**ADVICE IN RELATION TO THE POTENTIAL
IMPACTS OF COAL SEAM GAS EXTRACTION
IN THE SURAT AND BOWEN BASINS,
QUEENSLAND**

Phase One Final Report

**AUSTRALIAN GOVERNMENT
DEPARTMENT OF THE ENVIRONMENT,
WATER, HERITAGE AND THE ARTS**

Geoscience Australia and Dr M.A. Habermehl

Figure 2.1-2. Location of natural groundwater discharge sites (springs) with respect to coal seam gas tenements considered in the current assessment.

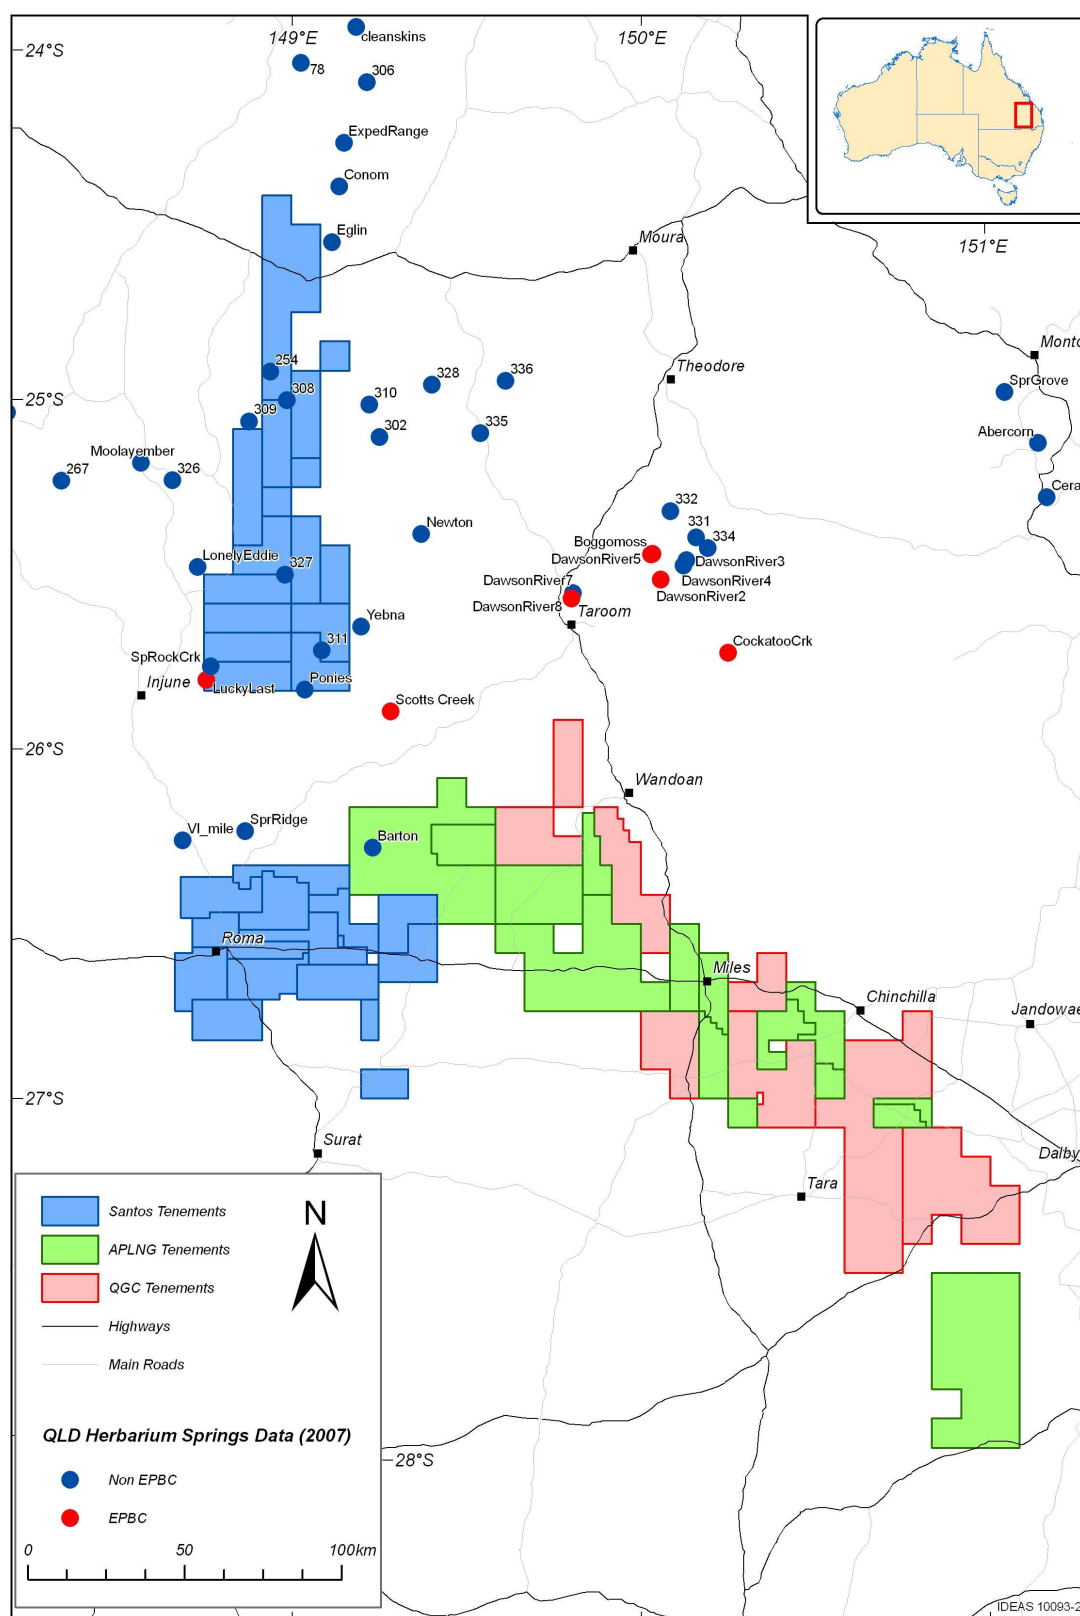
Only one registered “recharge” spring was identified within APLNG leases, in the western corner of the Pine Hills development area (Fig. 2.1-2). The spring is included on the Qld GAB WRP Springs Register and the Qld Herbarium database, but does not appear in the DEWHA mapping of Threatened Ecological Community - The Community of Native Species Dependent on Natural Discharge of Groundwater from the Great Artesian Basins. The spring is listed as ‘RJF Site No NV333’ and classified as active but not visited. APLNG hydrogeologists visited the site in July 2010 and reported no surface hydrological expression or vegetation indicative of a spring or GDE. The feature was reported as a possible seepage relating to an incised erosional feature at base of deep soil profile after significant rainfall (APLNG response to Geoscience Australia questions – 23 August 2010, p. 29).

APLNG identify numerous high value “recharge” and “discharge” spring complexes associated with the Hutton Sandstone and Precipice Sandstone units. These are located proximal to the Taroom and Injune townships, at least 50 km north and north-west of the northernmost APLNG development areas (DNR 2005). The “discharge” spring complexes located near Taroom are supplied by artesian flow from the Precipice Sandstone, rising to the surface through joints and fractures in that unit. These complexes are known locally as 'boggomosses', and provide a wetland habitat in an area that experiences prolonged below average rainfall conditions (DEWHA 2001) (APLNG Vol. 2, Ch. 10, p. 17).

APLNG have already adopted the recommendation put forward by their consultant (Hydrobiology – APLNG Vol. 5, Attach. 17, p. 126) that they undertake field investigations to confirm the classification and condition (as well as location, type, source aquifer) of springs north of Roma (Six Mile, Spring Ridge). In addition, we recommend that APLNG undertake investigations of the springs east of Taroom (Cockatoo Creek) in order to inform a revised route for the pipeline. Despite being outside the APLNG tenements and modelled range of drawdown, it would also be pertinent to assess the spring (Scott's Creek) north of the Pine Hill's development. This site is known to host EPBC significant communities and to account for any variation in the modelling results which may alter the extent of drawdown influence it is recommended that this site be fully characterised for baseline purposes.

Figure 2.2-2. Location of natural groundwater discharge sites (springs) with respect to coal seam gas tenements considered in the current assessment.

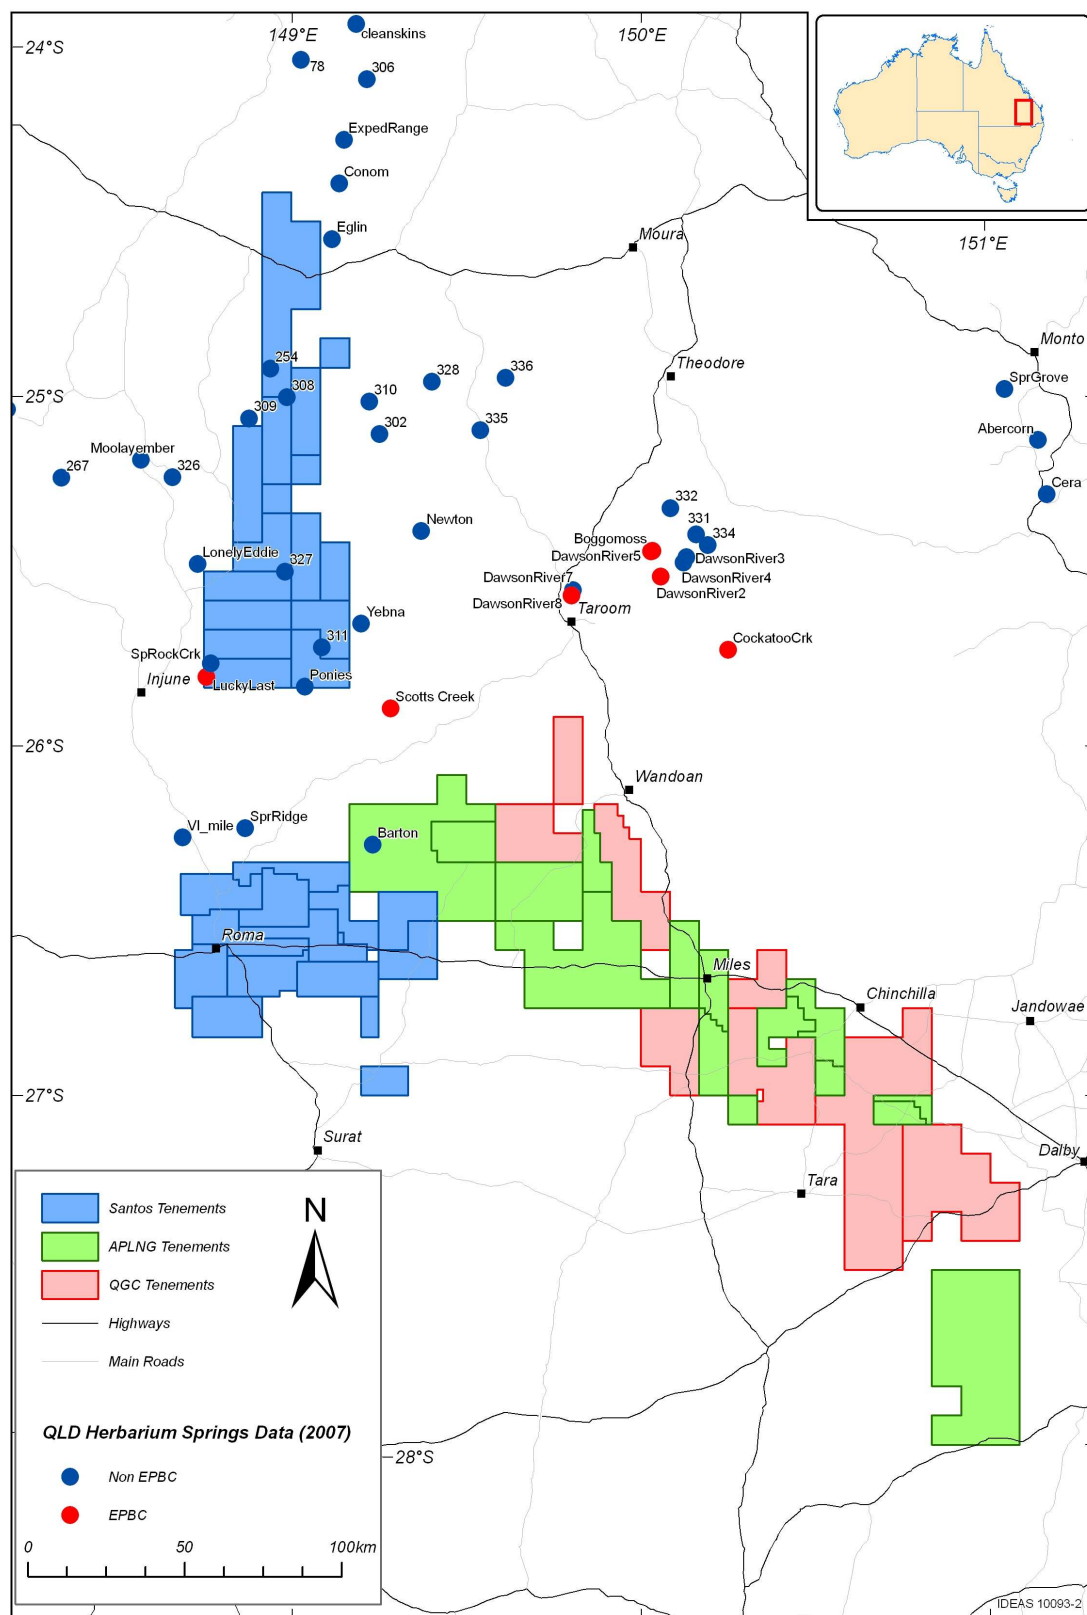
QGC provide little information in their main EIS documents regarding the assessment, monitoring and mitigation of potential impacts of groundwater extraction on the EPBC Act listed endangered ecological community ‘The community of native species dependent on natural discharge of groundwater from the Great Artesian Basin’. Initial assessment of an insignificant impact is the stated reason for this information not being considered in their final reporting (QGC Response to Geoscience Australia initial Assessment – 13 August 2010, p. 10), owing largely to the absence of any listed springs within or in close proximity to their tenements. Based on a review of the Queensland Herbarium Springs of Queensland Dataset (Version 4.0), QGC identify and report that no “discharge” springs or EPBC Act threatened communities of ‘native species dependent on the Great Artesian Basin’ occur within the study area (QGC Vol. 3, Ch. 8, p. 5).

GA and Dr M.A. Habermehl also identify no EPBC listed communities within the QGC tenements or within the QGC modelled zone of depressurisation. Some springs (type unspecified) are noted by QGC within 30 to 50 km of the CSG project area. At 30 to 50 km from the CSG fields QGC predict that drawdown in the Springbok Sandstone aquifer (Injune Creek Group), Hutton Sandstone and Precipice Sandstone aquifers will be negligible (QGC App. 3.4, Rep. 7, p. 72).

- QGC should be asked to detail what remedial action will be taken should groundwater drawdown be identified as impacting water quantity or quality in any springs, as all remedial measures currently proposed address only impacts on groundwater bores.

Figure 2.3-2. Location of natural groundwater discharge sites (springs) with respect to coal seam gas tenements considered in the current assessment.

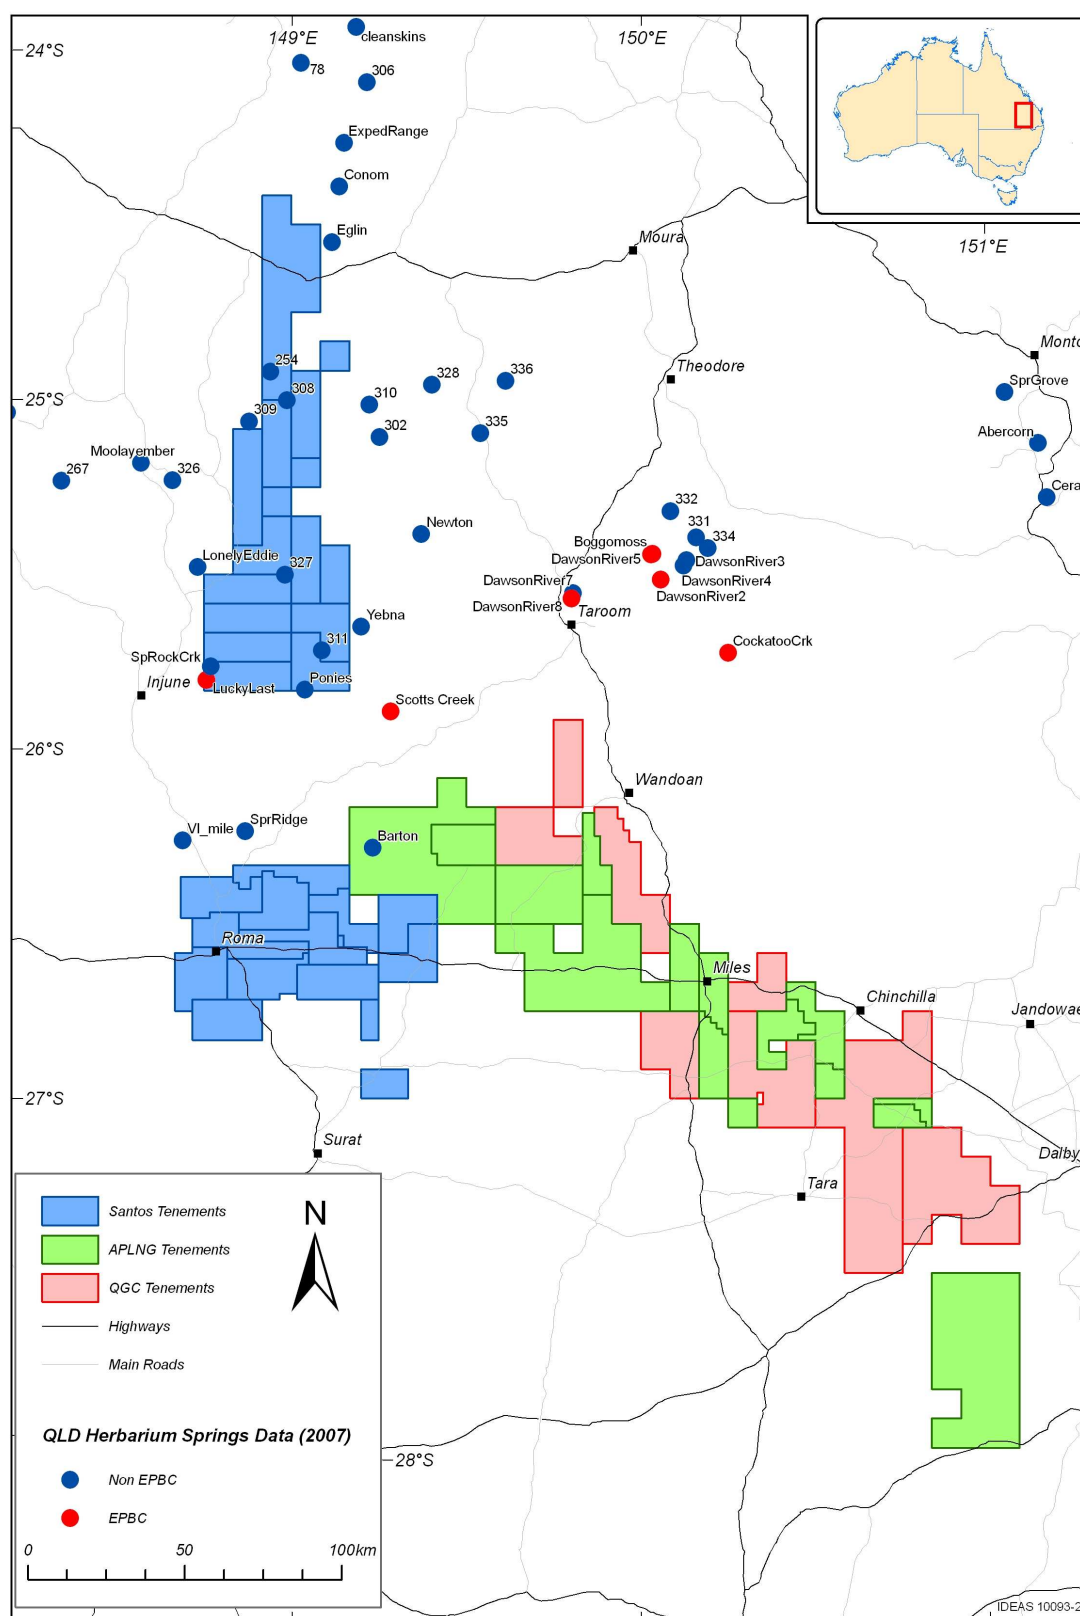
Dry season field investigations (Santos Appendix N4) identify no rare or threatened aquatic species at active artesian spring sites in catchments adjacent to and containing the Santos CSG fields. In the Upper Dawson catchment the endangered (and EPBC Act listed) macrophyte salt pipewort (*Eriocaulon carsonii*) has been recorded at the Hutton Spring Group on Hutton Creek (Fensham and Fairfax 2004), and the consultant's report suggests that artesian springs elsewhere in the CSG fields may support similar communities, where comparable geomorphic and hydraulic conditions are present. Furthermore the consultant identifies the likely presence of the EPBC critically endangered Boggomoss Snail (*Adclarkia dawsonensis*) in one of the Santos leases to the west of Taroom, but not in any of the Fairview, Arcadia or Roma tenements.

The Taroom 1:250,000 Geological Map Sheet Explanatory Notes (Forbes et al. 1967) report that "The mound springs in the Hutton Creek area, north-east of Injune, are probably supplied by artesian water from the Precipice Sandstone, which rises to the surface through joints or small faults." If the latter is correct, then these springs are "discharge" springs, and should be considered under the EPBC Act.

- Undertake detailed investigations of all springs within the groundwater model predicted drawdown extents. This would include detailed assessments of the EPBC significant Lucky Last and Scott's Creek springs in the vicinity of the Fairview CSG.
- Detail what remedial action might be taken should groundwater drawdown be identified as impacting water quantity or quality in any springs, as all remedial measures currently proposed address only impacts on groundwater bores.
- In order to estimate the potential for impacts caused by groundwater level drawdown, and the appropriate application of trigger values, the elevation of the spring (vent) and the potentiometric surface elevation of the source aquifer in the spring assessed should be determined prior to the onset of CSG groundwater extraction and be monitored throughout the production and recovery stages of the project lifetime.
